TECHNICAL SERVICE BULLETIN

Ting, Pop Or Clicking Noise From The Front Or Rear Wheel Hub When Accelerating Or Applying Brakes (Torque Reversals)

22-2395

Ford 2022-2023 F-150 Lightning
--

Figure 1

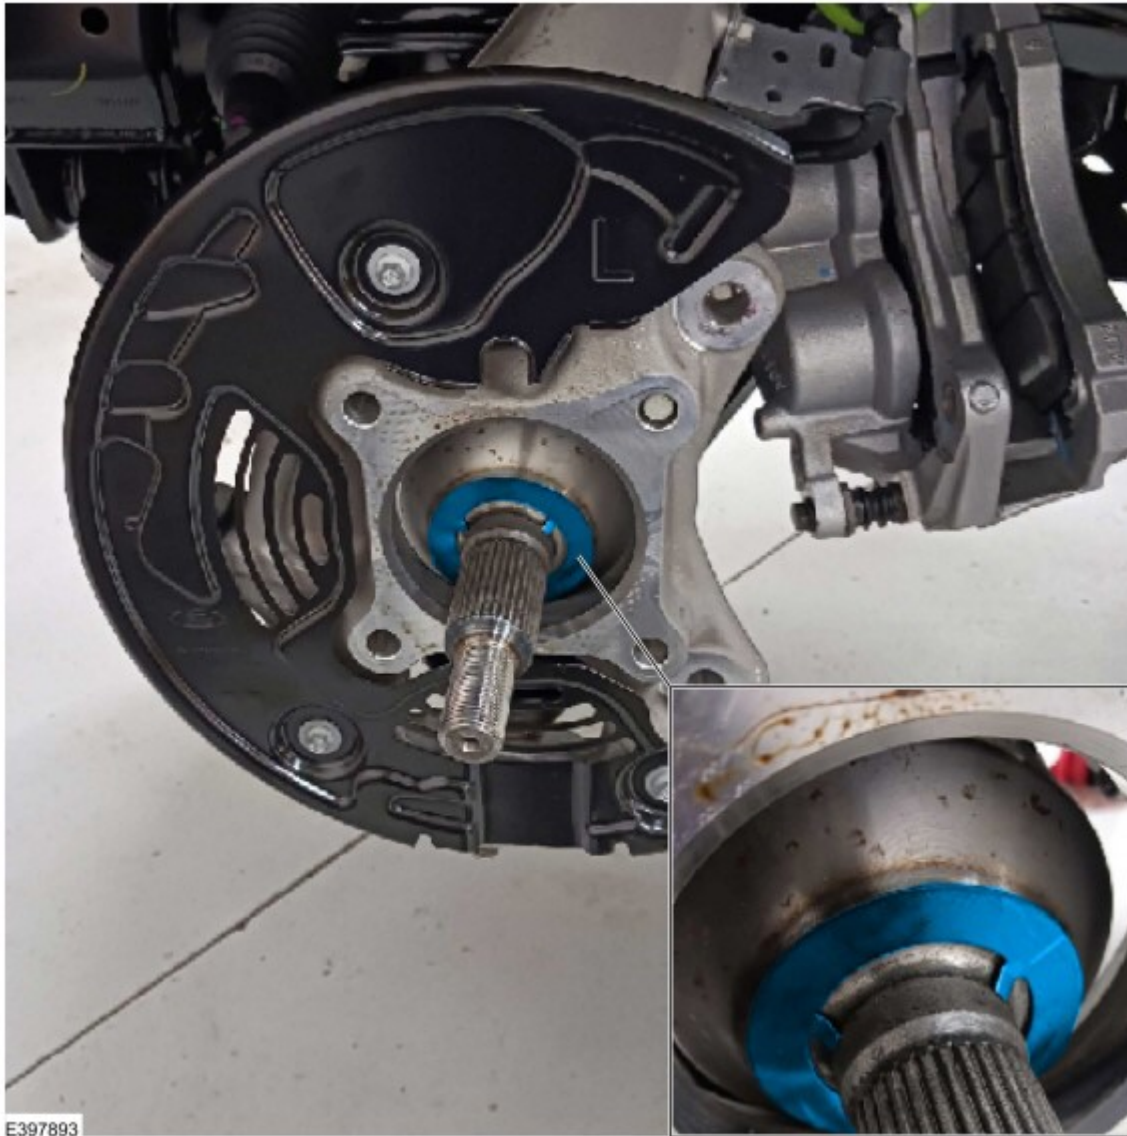
Issue: Some 2022-2023 F-150 Lightning vehicles may exhibit a ting, pop or clicking noise from the front or rear wheel hub when accelerating or applying brakes or when shifting between drive/reverse (torque reversals). This condition may be caused by stick/slip between the hub and halfshaft interface, during the torque reversals creating the ting/pop or clicking noise. To correct the condition, follow the Service Procedure to install the new anti-ting washer between the wheel hub and axle shaft.

1. Drive the vehicle to verify the concern, accelerate/apply brakes or shift from forward to reverse (torque reversals).
2. Does the vehicle exhibit ting, pop or clicking noise from the front or rear?
 - (1). Yes - add the anti-ting washer to both left and right halfshaft to hub interface for front and/or rear of the vehicle that exhibits the noise. (Figure 1)
Refer to the Workshop Manual (WSM) 204-02 Rear Suspension - Wheel Bearing and Wheel Hub > Electric Procedure or WSM 204-01B Front Wheel Bearing and Wheel Hub. Install the anti-ting washer between the wheel hub and axle shaft interface and reassemble.
